CABINET MEMBER FOR ENVIRONMENT – 12 APRIL 2018

A420 AT BUCKLAND – PROPOSED BUS STOP CLEARWAYS

Report by Director for Infrastructure Delivery

Title: S.278 Footway Links and Bus Stops Construction Plan

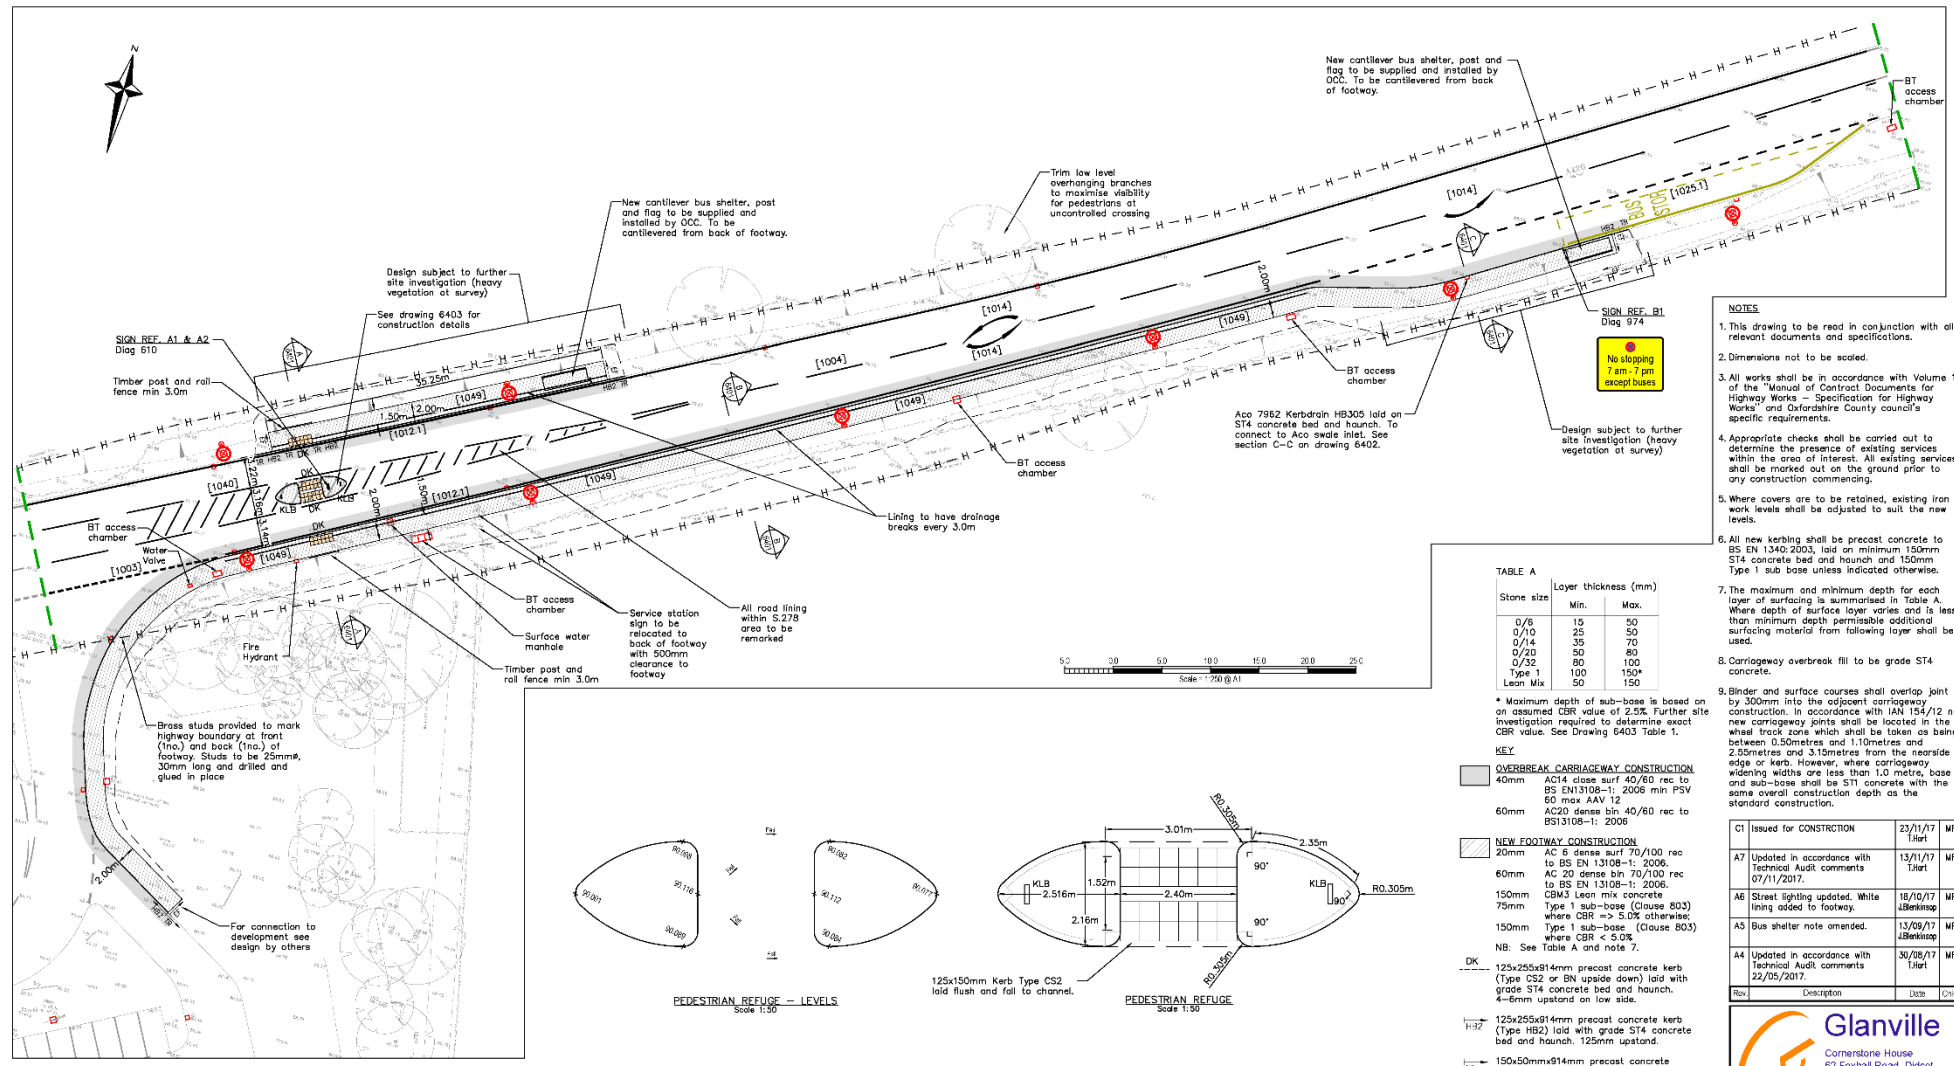
5. Thames Valley Police did not object to the proposal but raise some concerns and queries, which included the suggestion that providing a bus stop layby at the proposed stop on the north side of the road would be preferable (as is proposed for the new stop on the south side) and also that the proposed clearway within the layby (which is proposed to apply between 7am and 7pm) adequately catered for the anticipated use of the bus stop and would be of sufficient length to ensure that buses could pull back onto the A420 safely should a vehicle be parked in the layby in front of the bus stop.

7. County Councillor Heathcoat, the local member, while not expressing an objection to the proposal, noted that the A420 had a poor accident record and with increasing traffic volumes, the introduction of further bus stops could lead to potentially more hazards. Her main concern, however, was that the proposals did not include the provision of a continuous footway between the development and Buckland village, noting that the development would likely provide an employment opportunity for local residents (in particular young people) and also that residents may wish to use the retail store within the development. A further concern was that the proposed new pedestrian refuge required a good standard of lighting to ensure road safety, but equally that that should be designed to minimise light pollution.

11. Pusey Parish Meeting objected to the proposals on the grounds of road safety and traffic delays, the likely limited use of the stops and the preference for a footway linking the site to Buckland and the existing bus stops at the Buckland turn.

RESPONDENT	SUMMARISED COMMENTS
(1) Traffic Management Officer, (Thames Valley Police)	<p>Concerns - It is impossible to agree this proposal in the absence of what is proposed for the north side of this road . Dependant on where the Bus Stop is proposed I fear conflict with the new crossing point. Might I suggest an off road lay - by is considered the safest option for the north side as well. The layby restriction is timed, does this coincide with future bus time table? Should large goods vehicles park forward of the new Bus Stop Clearway ,will a Bus still be able to exit safely.</p>

(3) Local County Councillor, (Faringdon Division)	<p>Concerns - I wish to ensure that if these bus stops are to be installed that, as much consideration as possible is given to pedestrian safety and traffic safety – the A420 is notorious for its accident history especially in this area in my Division.</p> <ul style="list-style-type: none"> • Traffic is ever increasing travelling both east and west with the housing development taking place both in my Division and in the Swindon area. • Traffic weight is increasing too – commercial traffic/transporters all types of HGV's and farm vehicles. For a bus to make an entry into this traffic flow is getting increasingly more difficult – I see and experience these difficulties travelling the A420 daily. Having an additional bus “pull-in” with cause further traffic difficulties. • There are of course already 4 bus stops servicing this area both on the eastward and the westward bound journey of the A420 – 2 situated at or near the Buckland/Gainfield junction and then further along at Pusey Furze. • I would like the footpath that is being proposed just by the 2 new bus stops to be extended up to the existing

<p>(4) Vale of White Horse District Council</p>	<p>No objection.</p>
<p>(5) Pusey Parish Meeting</p>	<p>Object – In summary:</p> <ul style="list-style-type: none"> • Pusey will not benefit, and may even be disadvantaged (see below), by the new bus stops. • There is no Little Chef, so why is this being pursued. • There is no footpath to the stops, except from the site of the new motel. How will people get to and from the stops? And if they do go there for the buses, will they be able to park at the motel without using it? • Any bus stopping on the East going side will create a blockage on the A420, which can be congested anyway, and the pedestrian refuge is a further obstruction near a junction – is that sensible? • There are bus stops about 500m West, at the Buckland junction. These must remain, as the best site to serve Buckland. So will buses stop at the new ones as well? • A stop on the North side would encourage pedestrians to cross the road where there is no pavement or path to anywhere else, which is dangerous anyway. • There are footpaths that come to the A420 from Buckland and Pusey, 200 m West of the motel site. It would be far more sensible to make a safer crossing point there, and a pavement along the road between the Buckland crossroads and the motel/filling station, if there is money to be spent. <p>All in all, this appears to be a project that dates from a time when the Little Chef was there, and is now out of date. Why has it not taken account of the changed circumstances? Is it that there is money to be spent in the programme, and it has a momentum that cannot be stopped?</p> <p>Are the proposed bus stops to enable staff to get to and from the site? If so, this seems exceptional, and possibly unjustified. It would reinforce the view that a pavement from the existing Buckland stops along the South side of the</p>

6. The above concerns are noted although it is not considered viable to provide a bus stop layby on the north side of the road taking account of the costs and that land acquisition may well be required. It is, however, agreed that it would be advisable to extend the hours of operation of the bus stop clearway to apply between 6am and midnight, and also to extend the clearway marking to the west to address the concern that buses may be impeded when exiting the layby by other vehicles parked to the west of the bus stop within the layby.

8. It is accepted that the new bus stops and refuge will introduce new potential conflicts but also it should be noted that the existing bus stops on the A420 thankfully have a very good safety record and there is no reason to expect that the safety performance of the proposed new stops will be any different. It is confirmed that lighting will be provided for the refuge and that equipment will be designed to provide adequate illumination while also minimising light pollution.

9. It is agreed that in principle the provision of a footway linking the development to the Buckland turn would be desirable for the reasons mentioned by Councillor Heathcoat but, unfortunately, it is not considered possible to require the developer to fund that provision given that planning consent was given on the basis of the current proposals. Opportunities for funding this provision will be explored but it is currently unclear as to whether there is a realistic prospect of this being progressed at least in the short to medium term.

12. While the above concerns are noted, provision of bus stops close to the development site is considered to be required to facilitate journeys by staff in particular to and from the development, given that the existing bus stops by the Buckland turn are around 500 metres to the east. As discussed above, the

existing bus stops on the A420 operate with good levels of safety and without causing any appreciable delays to traffic and, while it is agreed that a footway link would be desirable in principle, it is not considered viable to progress this in the context of the current development.
